ORIGINATION FORM

Proposed Revisions to a Standard Plans Index

Index Number: 641-020

Index Title: CONCRETE CCTV POLE

SHEET
2 of 5

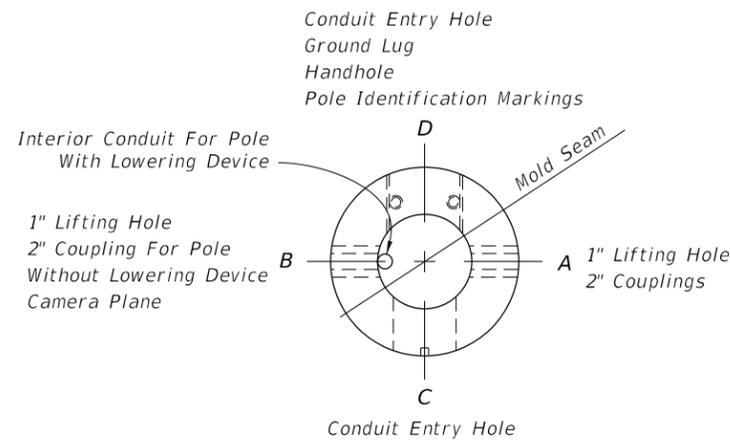
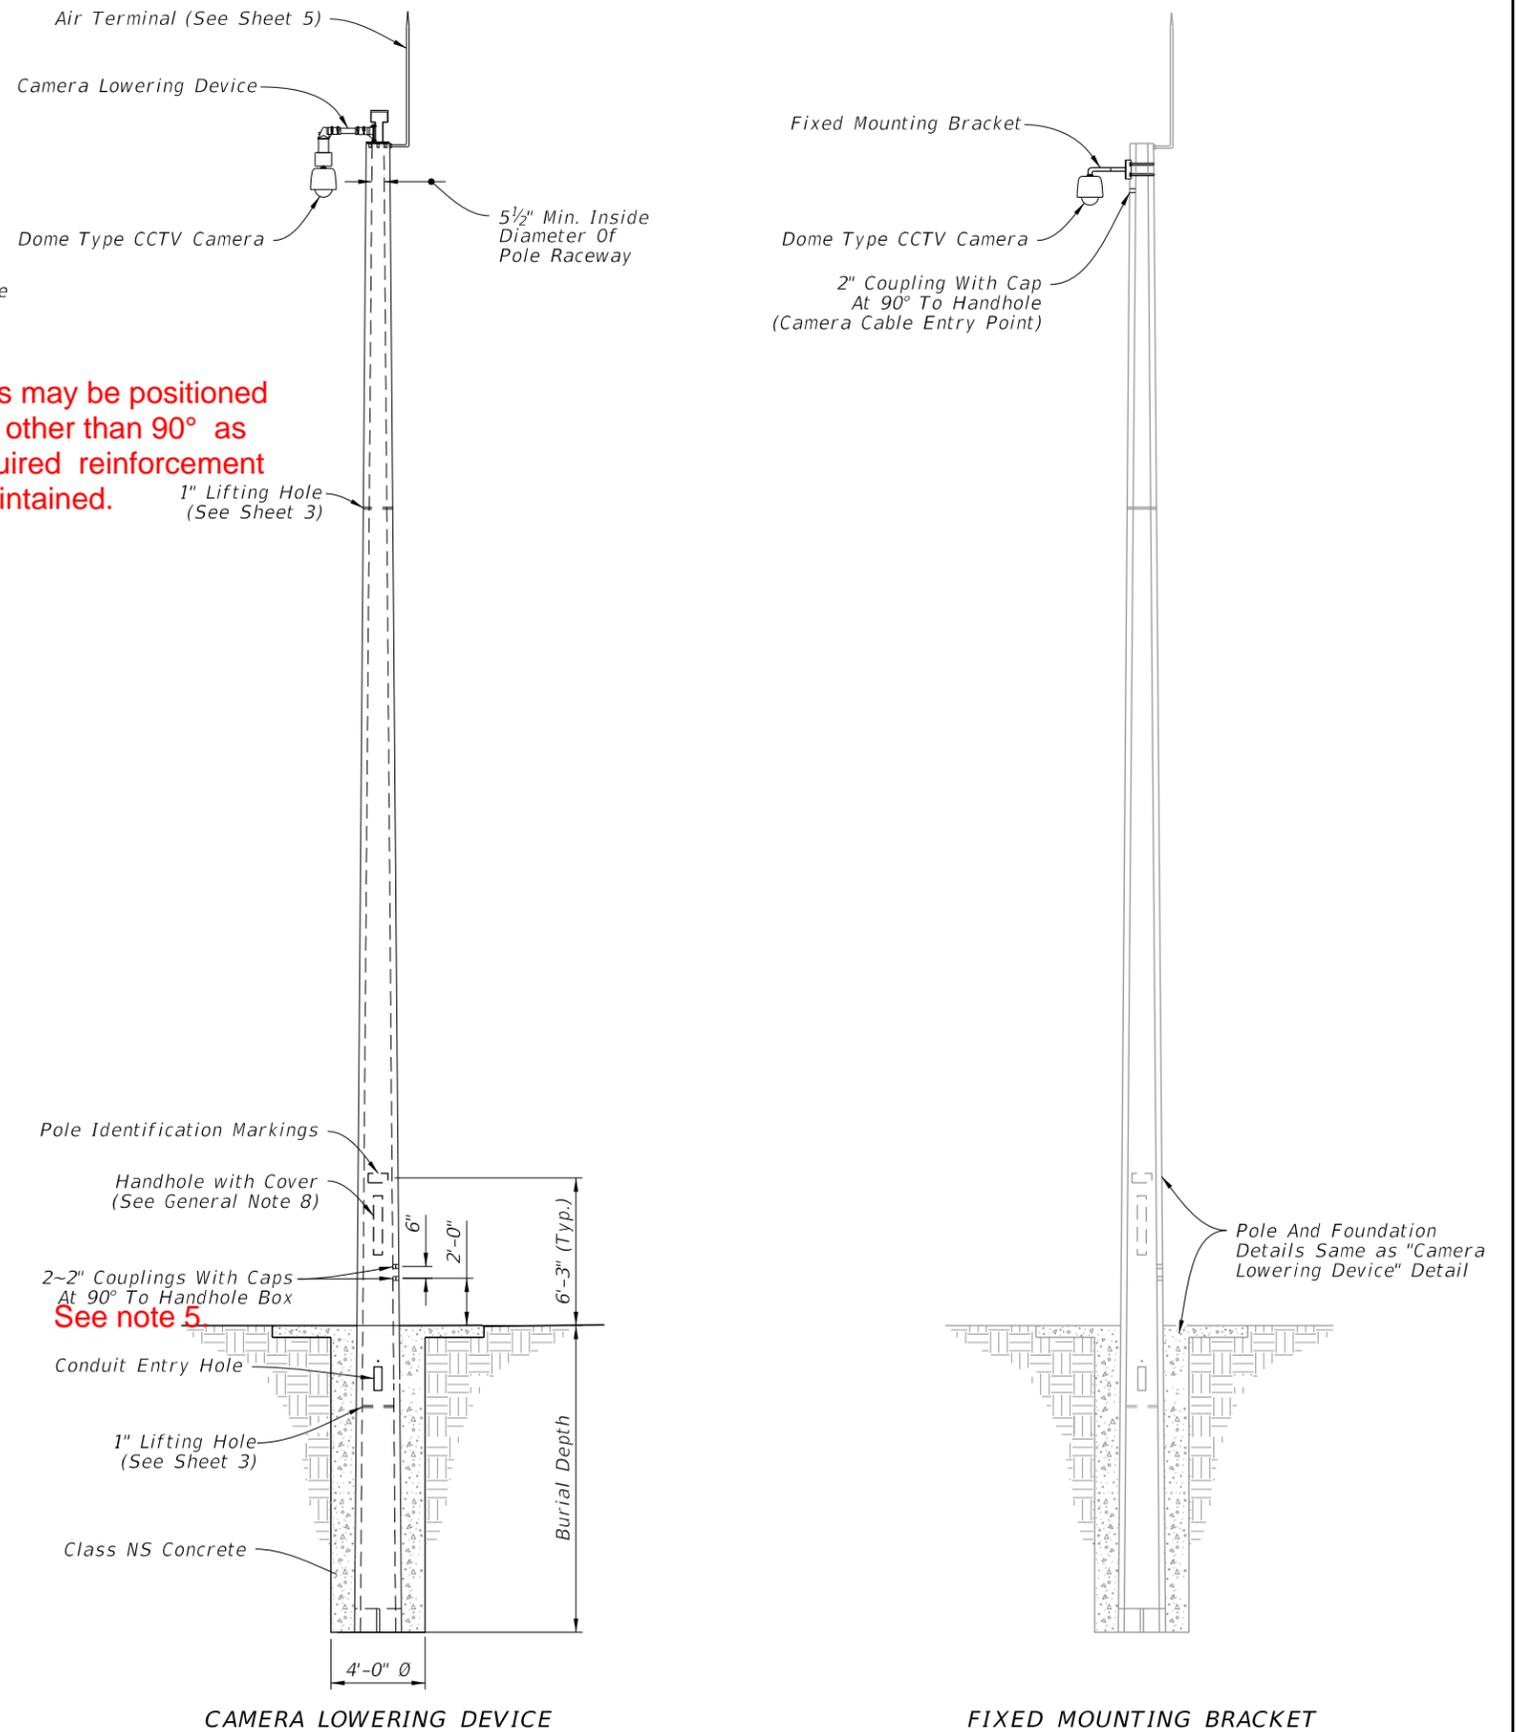
Sheet 2: Added a note allowing the couplers to be positioned at other radial locations.

Sheet 2: Fabricators asked if could position the cabinets at other locations radially. We added a note to allow this.

5. Couplings may be positioned at locations other than 90° as long as required reinforcement cover is maintained.

LAST REVISION 11/01/21	REVISION 11/01/23	DESCRIPTION:	FDOT	FY 2023-24 STANDARD PLANS	CONCRETE CCTV POLE	INDEX 641-020	SHEET 3 of 5
---------------------------	----------------------	--------------	------	------------------------------	--------------------	------------------	-----------------

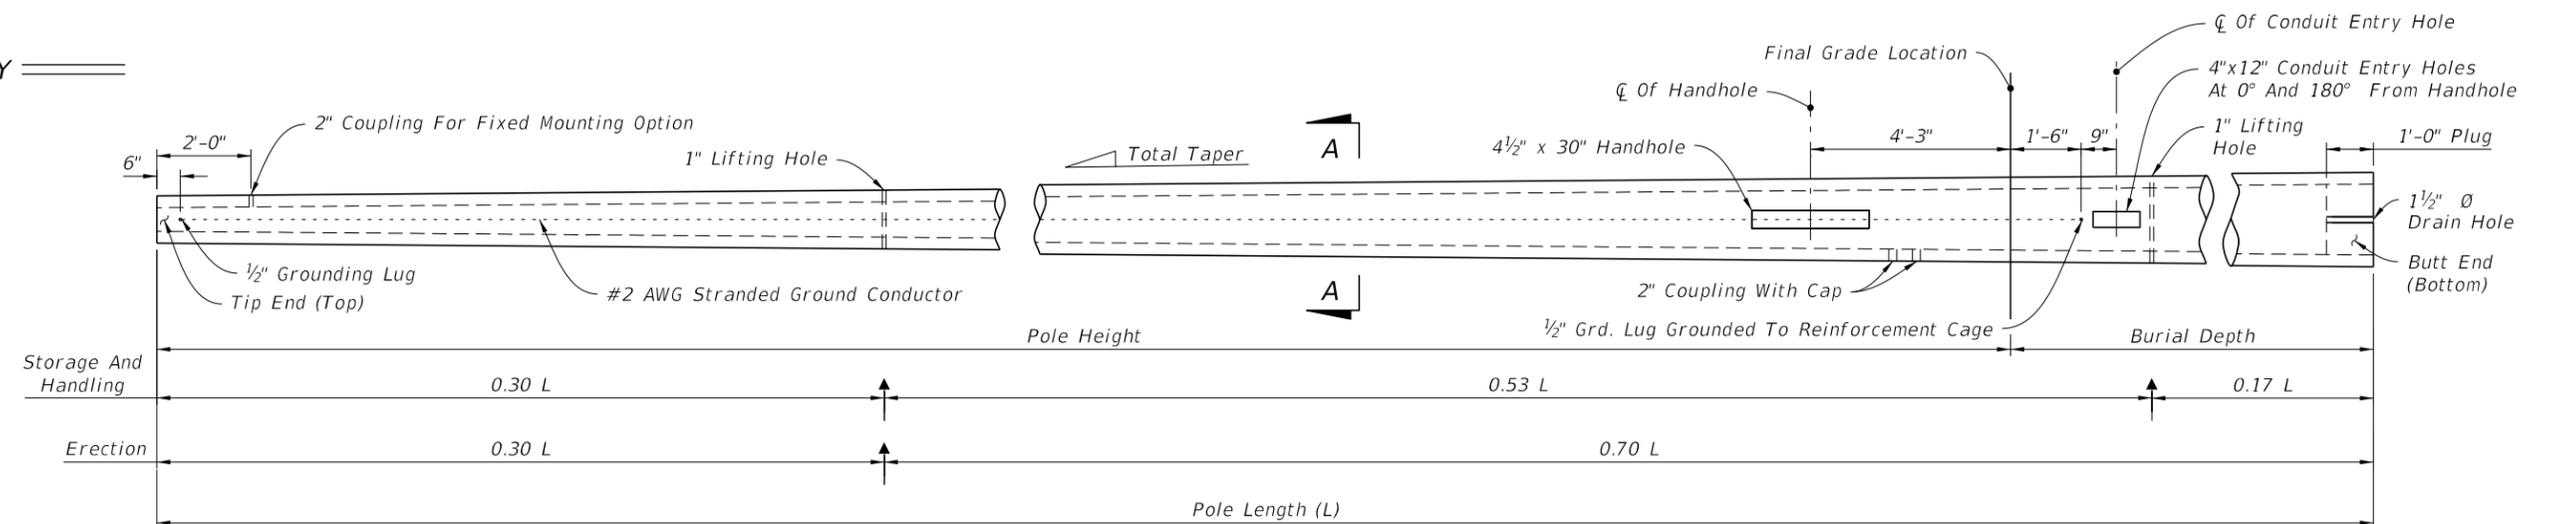
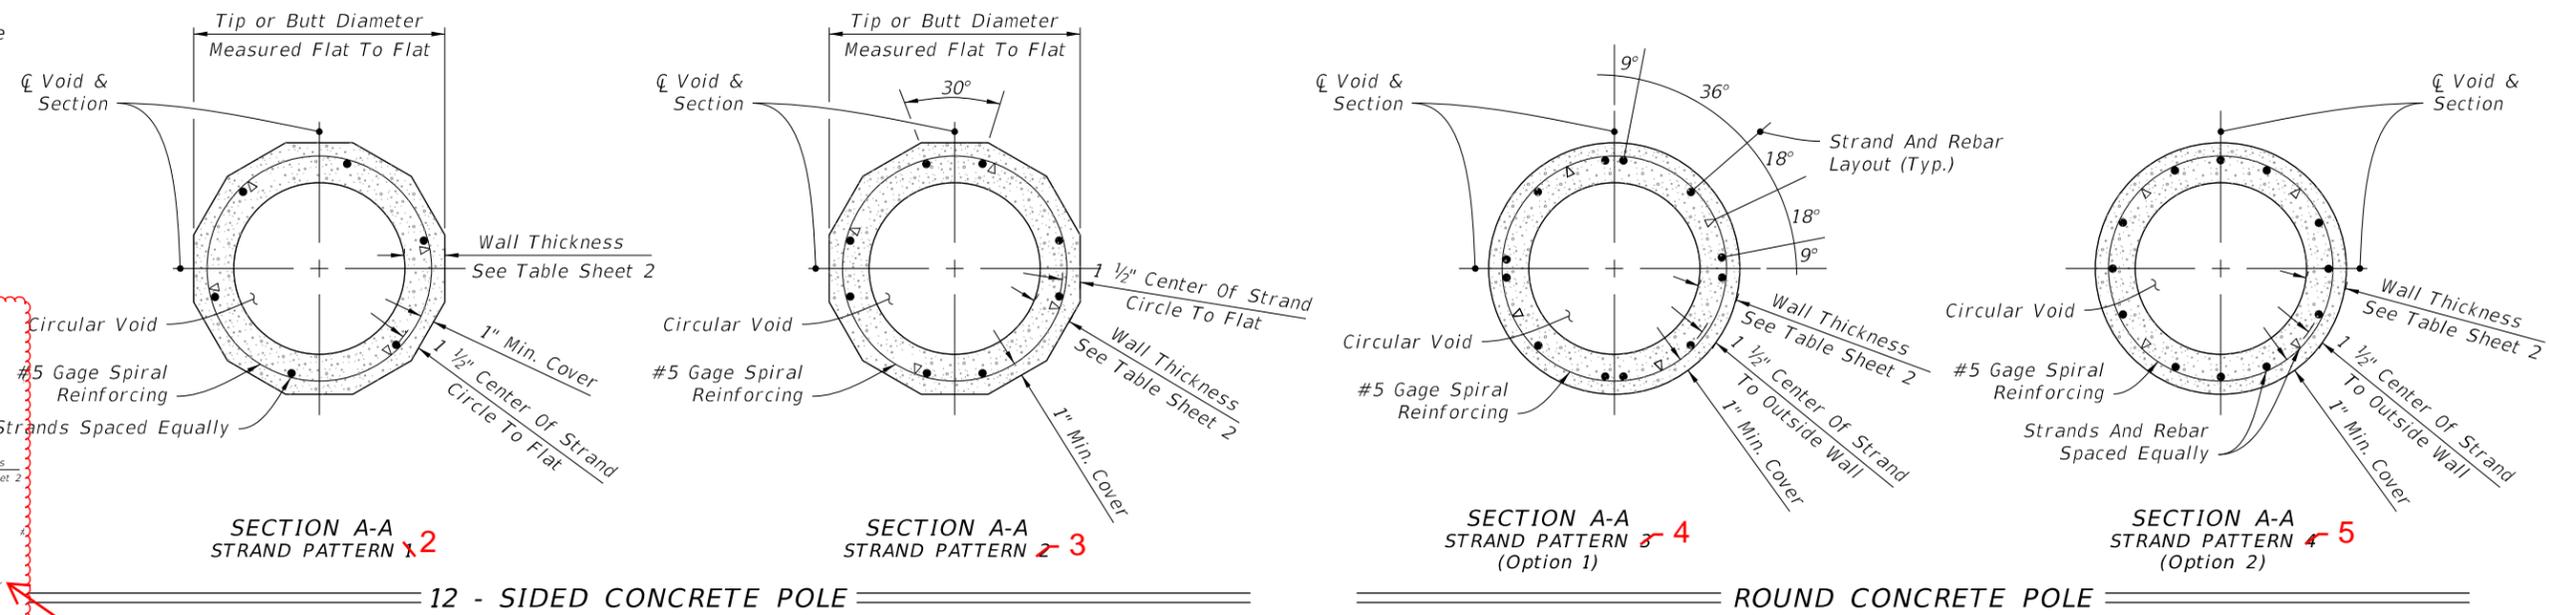
Sheet 3: Added a new strand pattern.

Sheet 3: A fabricator of 12 sided poles had an approved strand pattern in their QC plan which differed from the Standard. The difference allowed the fabricator to mount the hand hole on the flat of the pole and maintain reinforcement cover. We have adopted this in the Standard to provide consistency between the QC plan and the Standard.

Added New Strand Pattern Detail
